Response to Reviewer 1:

Response to Reviewer 2:

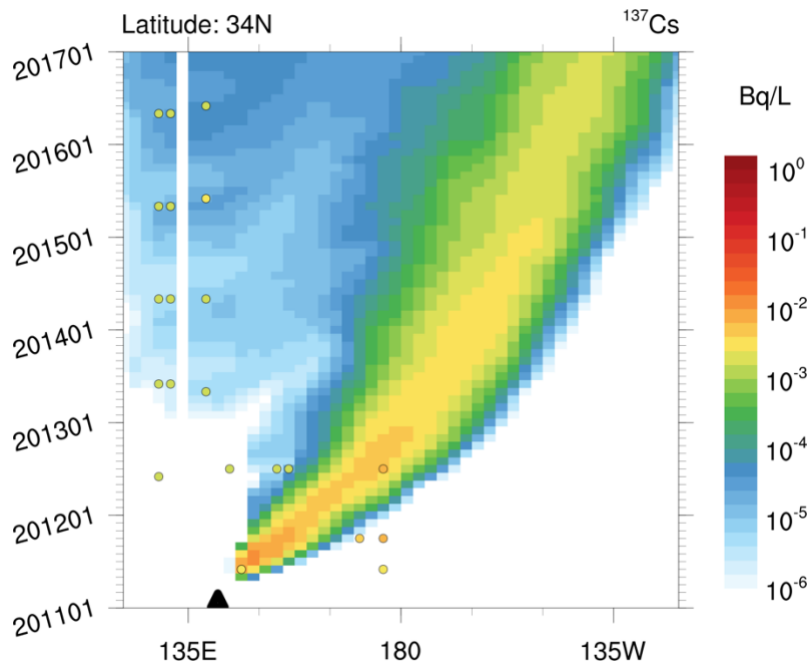
Figure 1: Since background concentrations of Cs-137 in the North Pacific after 2011 are above $1.0\text{E-}3$ Bq/L, the color scale used is inappropriate, with the entire comparison range shown as red. The comparison should be made over a range of $1.0\text{E-}3$ Bq/L to 1 Bq/L.

We agree with this comment. We have revised the color scale of Figure 1 to range from $1.0\text{E-}6$ Bq/L to 1 Bq/L to more accurately reflect the observed concentration range of Cs-137 in the North Pacific, which is typically between $1.0\text{E-}3$ Bq/L and 1 Bq/L. This adjustment allows for a more meaningful comparison between simulated and observed concentrations.

Line 242: “Fig. 1. Zonal evolution of surface ^{137}Cs concentration along the latitude of the FDNPS. The contour plot shows model-simulated concentrations, while overlaid scatter points represent observations from literature (Kaeriyama et al., 2013; Oikawa et al., 2013; Buesseler et al., 2017; Takata et al., 2018; Kenyon et al., 2020). The color scale is set between 10^{-6} Bq L^{-1} and 1 Bq L^{-1} to include the observed background levels ($\sim 10^{-3}$ Bq L^{-1}) in the North Pacific.”
